Revision Notes, Rev0 to Rev2:

Itemref	Quantity	Title/Name, designation, material, dimension etc			Article No./Reference	
Designed by A W Newby	Checked by D Pennington	Approved by - date D Pennington 14/10/2021	Filename Access.Rev2.dwg	Date 14/10/2021	Scale 1:200	
PME Planning Services				Access Plan		
4.2				Edition Rev 2	Sheet 1/2

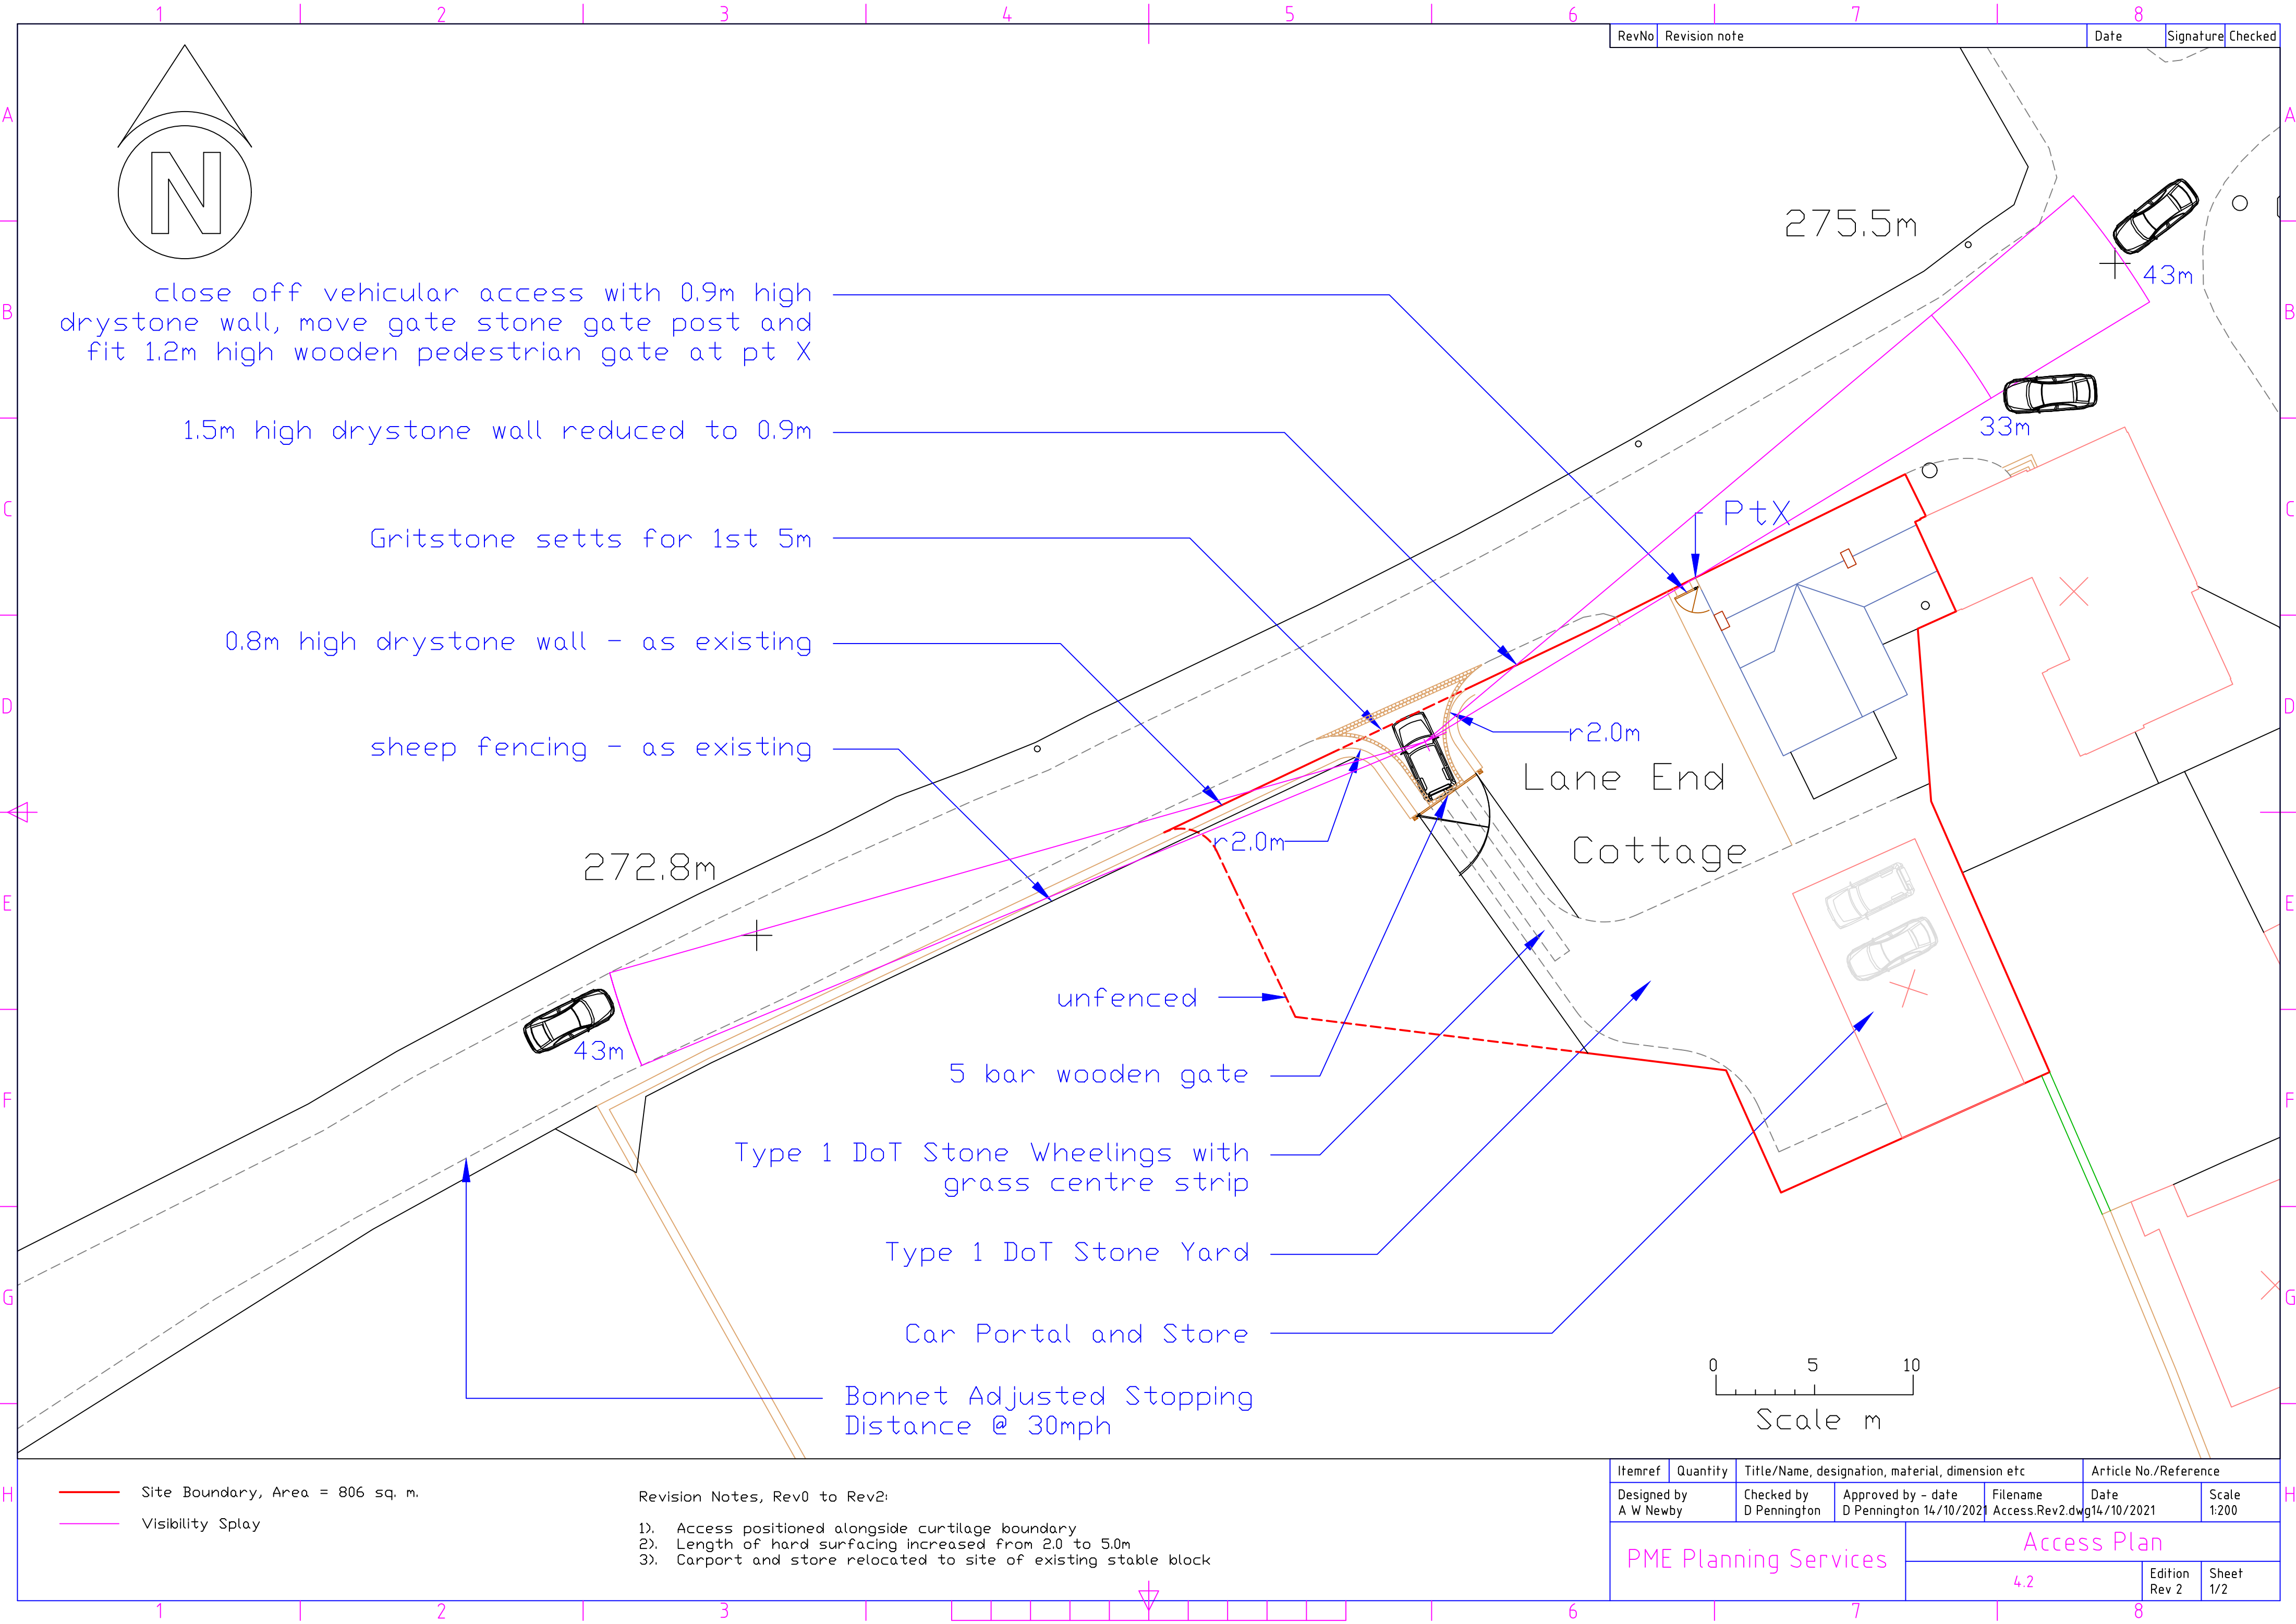
close off vehicular access with 0.9m high drystone wall, move gate stone gate post and fit 1.2m high wooden pedestrian gate at pt X

1.5m high drystone wall reduced to 0.9m

- Access positioned alongside curtilage boundary
- Length of hard surfacing increased from 2.0 to 5.0m
- Carport and store relocated to site of existing stable block
